Te Puru- 867 Whitford- Maraetai Road, Whitford

Date: 16 March 2023
Time: 12:30 pm
Venue: Teams meeting
Attendees: Elmira Vatani (EV) – Auckland Transport (AT)
Chris Freke (CF) – Auckland Transport (AT)
Terry Church (TC) - Flow
Renee Fraser -Smith (RF) - Tollemache

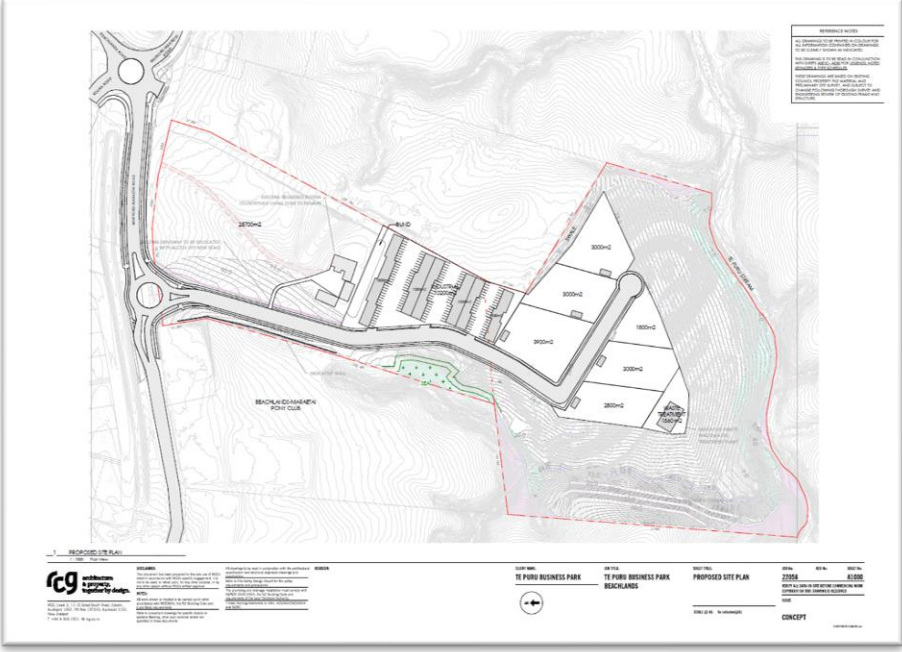
<p>A cover letter prepared by TC, dated 16 March 2023 was also sent to both EV and CF following the close of the meeting further explaining the proposed development.</p>
<p>Proposed access and a roundabout</p>	<p>During the discussion, EV raised concern about potential visibility issues due to the steep contour of the access point. Additionally, a question was raised about the closure of the service access lane at the Beachlands Road roundabout. In response, RF explained that the neighbouring property has a water-take consent that is not yet implemented, and therefore the access to the neighbouring site cannot be removed. No discussion has been held with the neighbouring site regarding the closure of this service lane. However, access to the subject site will be provided from the proposed access.</p> <p>TC confirmed that the access gradient will be 5% and will comply with the AUP requirements for all modes of transport. He also stated that the visibility assessment has been conducted and taken into consideration during the design of the roundabout.</p> <p>RF explained that the intention is to design the private access in accordance with AT's local road standard, but not to vest it to the Council. However, a public access easement will be provided over this access for pedestrians and cyclists. During the inquiry, CF raised a question about the Pony Club's access to the proposed accessway. RF clarified that the Pony Club will have its access off Whitford-Maraetai Road and no discussion has been carried out to relocate their access off the proposed accessway. However, they can relocate it if they wish, provided that the gradient from this access is acceptable; but, if they choose to relocate, then it will require a right-of-way easement (if not vested as public road).</p> <p>CF mentioned that Whitford-Maraetai Road may be upgraded to four lane, as AT has a road widening designation over this corridor. An assessment is required to demonstrate the proposed roundabout and access can safely and efficiently operate in the event corridor is upgraded to four</p>

<p>lanes. It was acknowledged by AT that this section the road may not ultimately require 4 lanes though, something that PC88 (if approved) would be unlikely to change. However, any significant infill in the event the PC78 qualifying matter is not upheld may necessitate the need for 4 lanes.</p> <p>TC expressed view that proximity to and future upgrading of Jack Lachlan Drive to either roundabout or signals would be unlikely lead to any operational issues with the proposed roundabout.</p>
Post meeting comments/ information required	<ul style="list-style-type: none"> - The intersection, its treatment, and the active mode facilities along Whitford-Maraetai Road are supported in principle and are not considered to have any outright “fatal flaws” that cannot be resolved through a consenting and subsequent detailed design process. - The proposed land use would create some additional business land to support the current Beachlands dormitory suburb and is supported in principle. It is a discrete piece of former quarry land with clear natural boundaries and therefore presents very low risk of encouraging further urban expansion to adjoining sites. - It is agreed the new roundabout presents a better access option than the current one serving the quarry. - AT supports ancillary “tidying up of the current access to the quarry” and removal of current driveways onto Whitford-Maraetai Road. It therefore would support the new access being used by the pony club in the event this proved feasible. Any required treatment of run off from the new roundabout needs to be located within a public road reserve or protected by way of easement if within a private access. - AT would be open to the new access being design, constructed and vested as public road. - A visibility assessment should be provided in support of the preferred access Option as the contours are very steep. Guard railing may also be required. - The proposed intersection and a roundabout should be subject to a Road Safety Audit to ensure that the design/layout is safe and functional as part of detailed design (Engineering Approval stage) before any road assets are constructed and vested to the Council. The overall assessment and ‘general’ design needs to occur as part of the resource consent (or Fast Track) process and there needs to be a high level of certainty that the design / layout agreed as part of a resource consent (or Fast Track) is safe, functional and workable. - A s176 approval should be provided as part of the resource consent (or Fast Track) application for the proposed works located within AT’s Designation – 1806, Road Widening – Beachlands Road, Designation. Otherwise, the effects should be assessed/addressed in the AEE accordingly.
